# A303 Sparkford to Ilchester Dualling Scheme TR010036

## 9.20 Responses to Action Points for Deadline 5

**Responses to Action Points for Deadline 5**

| Drawing Title<br>TOURIST SIGNAGE STRATEGY             |                                |                   |                            |                  |                   |

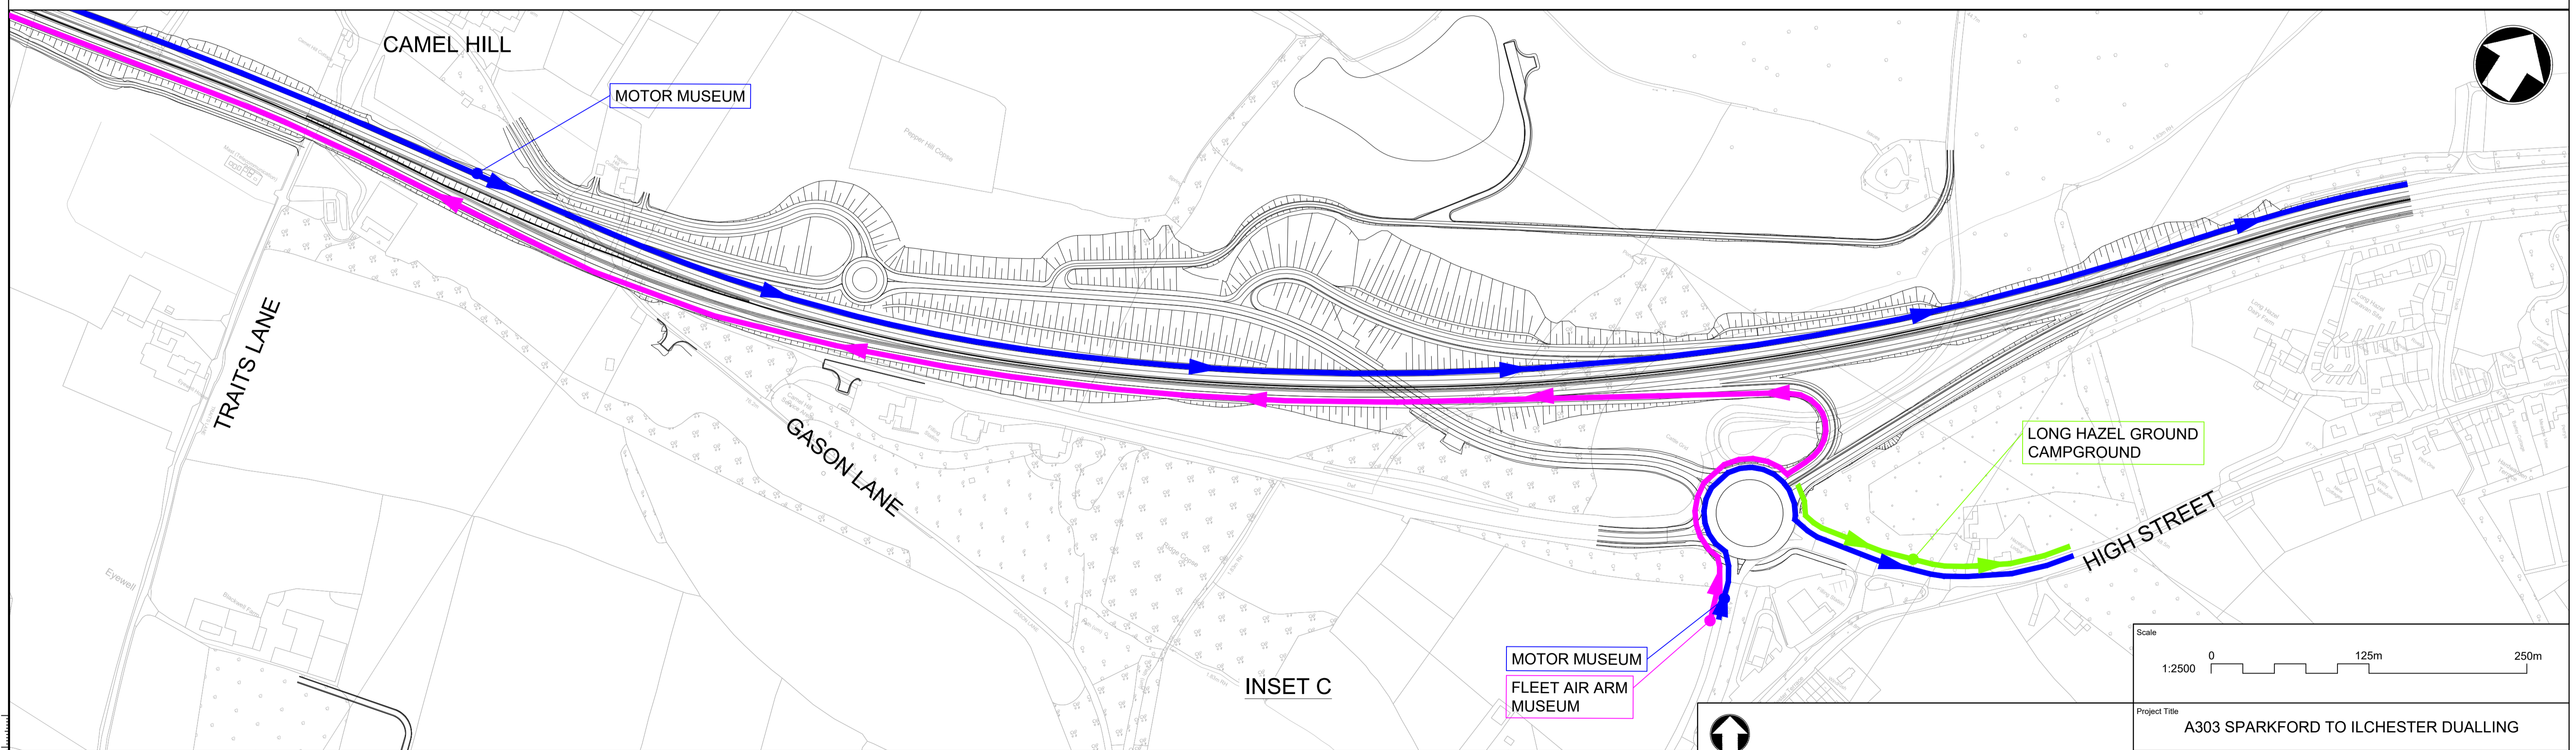
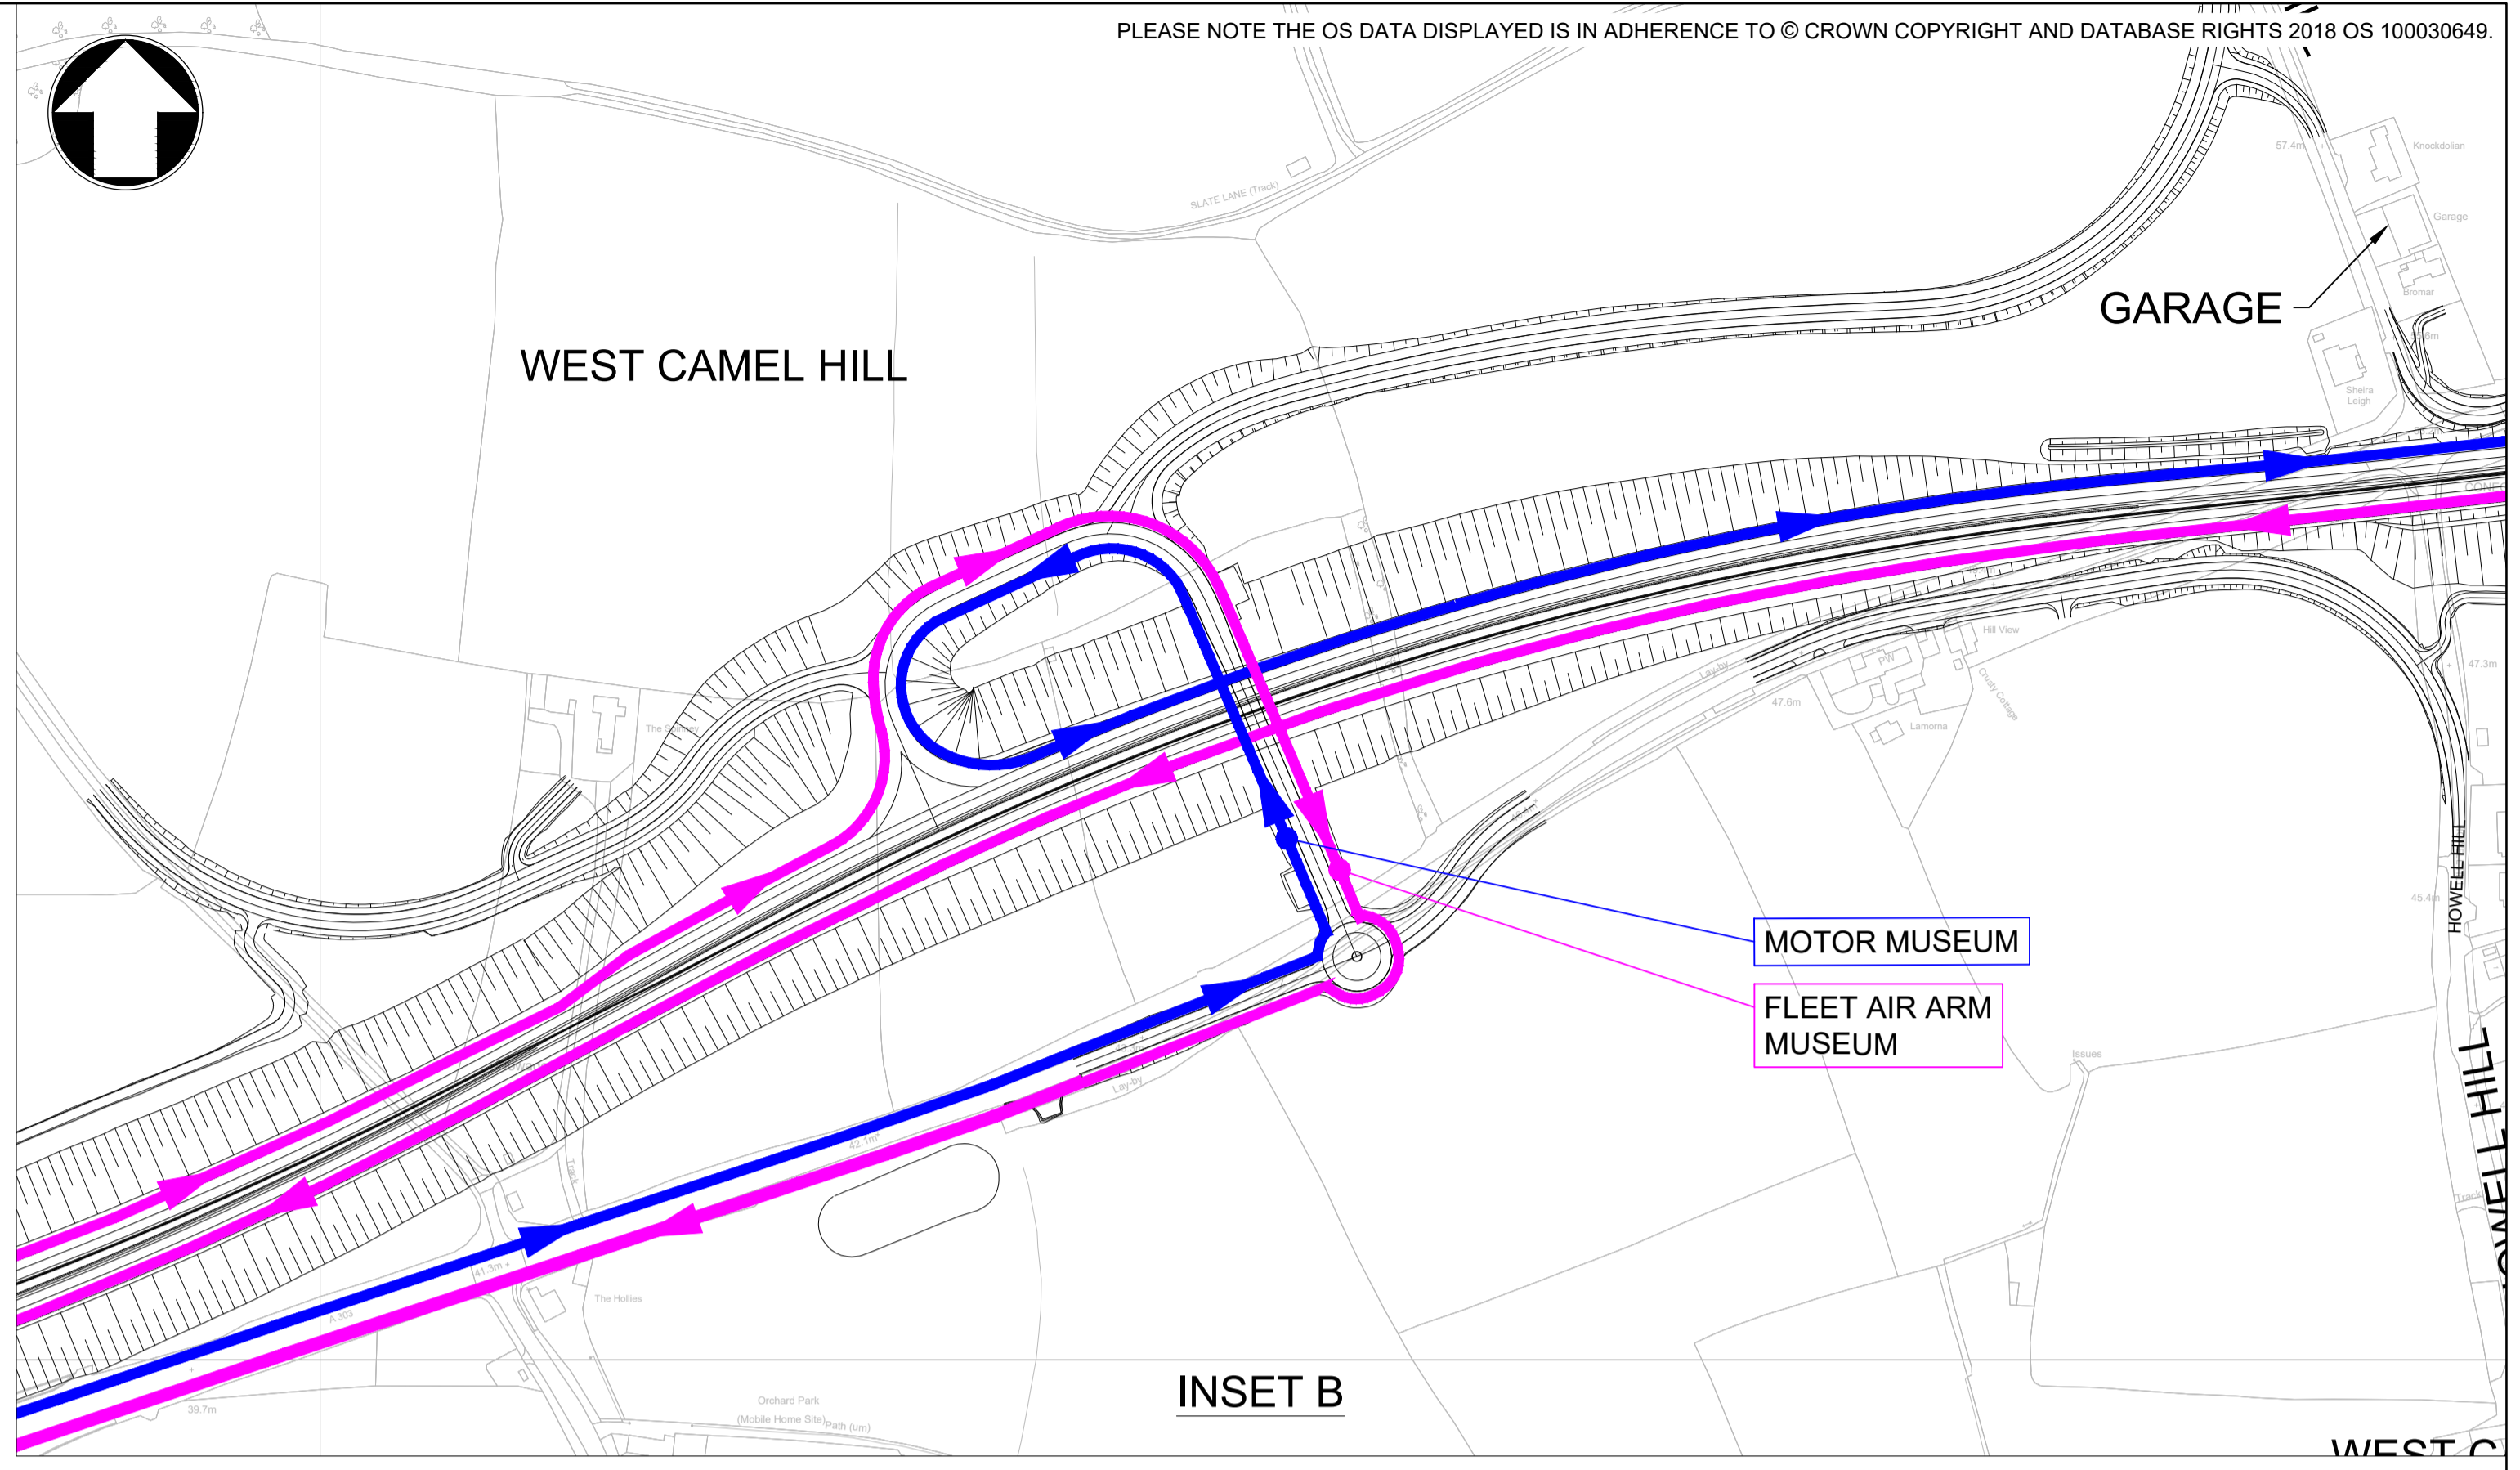
2.1.57 Action Point 43 requests: *Confirmation of how Signage Strategy is to be delivered under the dDCO.*

The tourist signage strategy is shown in drawing HE551507-MMSJV-000-HGN-DR-CH-0206 (Appendix B of this report). The destinations included in the strategy are the Fleet Air Arm Museum, Motor Museum and Long Hazel Camp Ground.

The Fleet Air Arm Museum is currently signed along the A303 eastbound from as far as Junction 25 of the M5. The museum is also signed westbound from the existing Hazlegrove junction, including the A359 northbound approach to the roundabout. The signage strategy reflects this, providing signage from the A303 eastbound at Downhead and the A303 westbound at Camel Cross. The signage from the A359 northbound approach to Hazlegrove is also maintained, although in order to rationalise signage at the westbound approach the museum is not signed on the A303 westbound approach to Hazlegrove.

Haynes International Motor Museum (signed as 'Motor Museum') is currently signed from the B3151 approach to Camel Cross and the A359 northbound approach to Hazlegrove. This is maintained in the proposed strategy.

The motor museum is also currently signed on the A303 westbound approach to the Hazlegrove junction. However this has been removed from the proposed strategy in order to rationalise signage on the nearside westbound verge, on reflection of the fact the westbound drivers are actually directed to leave the A303 at the previous junction (South Cadbury).

The Long Hazel Campground appears to have an advance sign on the A303 eastbound and westbound approaches to the Hazlegrove Roundabout, and on the A359 exit from the roundabout itself. The signs on the existing A303 approach will not be retained although the campground will be signed from the Hazlegrove roundabout onwards.
